SERVICE INFORMATION LETTER

SERVICE INFORMATION LETTER NO. 0057
Page one

Date: January 27, 1977
Subject: Main Rotor Gearbox Retention Bolts
Models: F-28A, 280, F-28C, 280C
Effectivity: As Noted Below

Fig. A-2

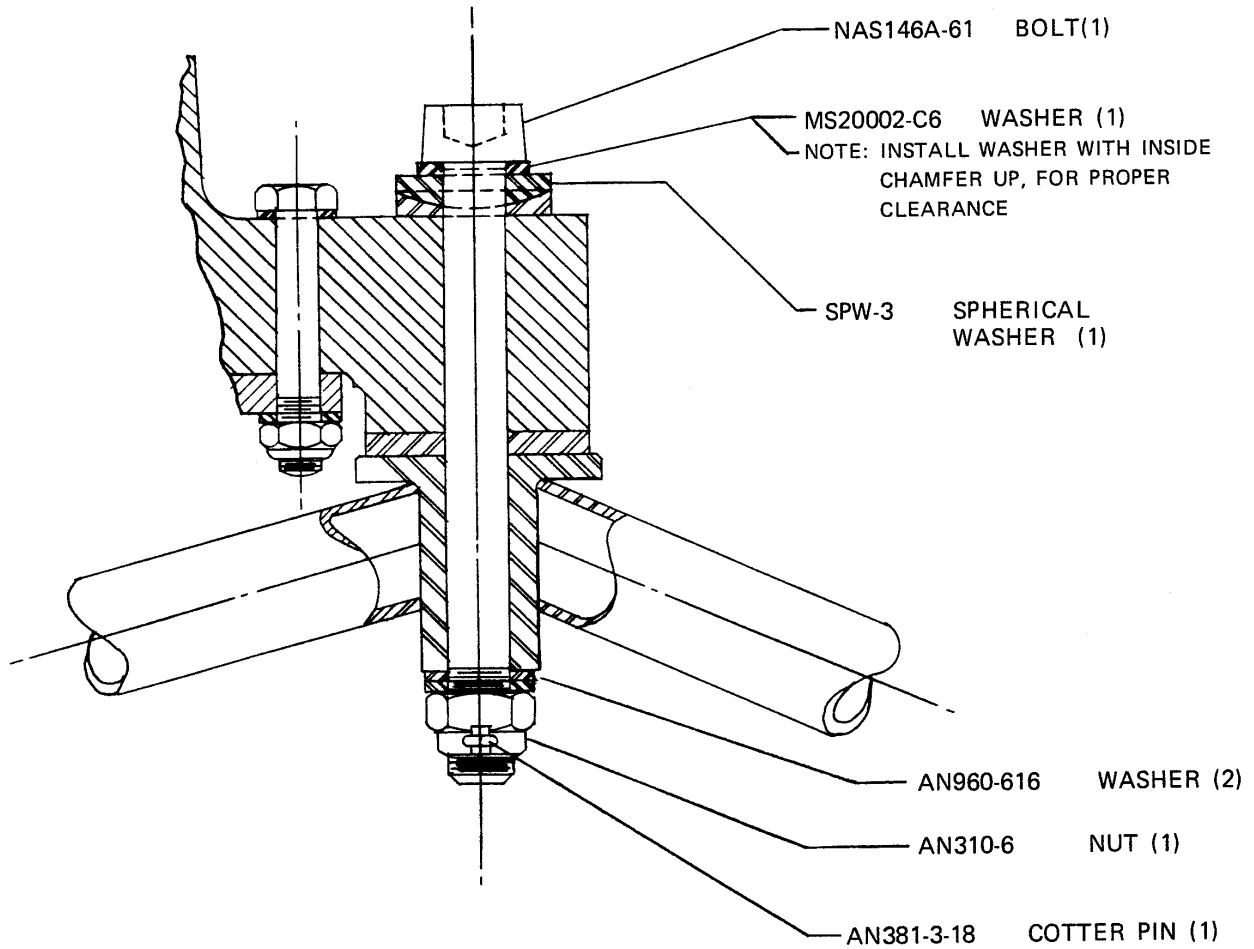
An isolated occurrence has been reported of one main rotor gearbox retention bolt failure. The AN6-33 bolt failed under the head and was a direct result of a nonparallel surface under the bolt head and washer.

On all main rotor gearboxes prior to S/N 42-006-76PS, the (4) AN6-33 retention bolts should be removed and replaced with (4) NAS146A-61 bolts, (4) MS20002-6 washers, (4 sets) SPW-3 spherical washers, (4) AN310-6 nuts, (4) AN381-3-18 cotter pins, and installation of AN960-616 washers as required under nut. See Figure 1 on page two.
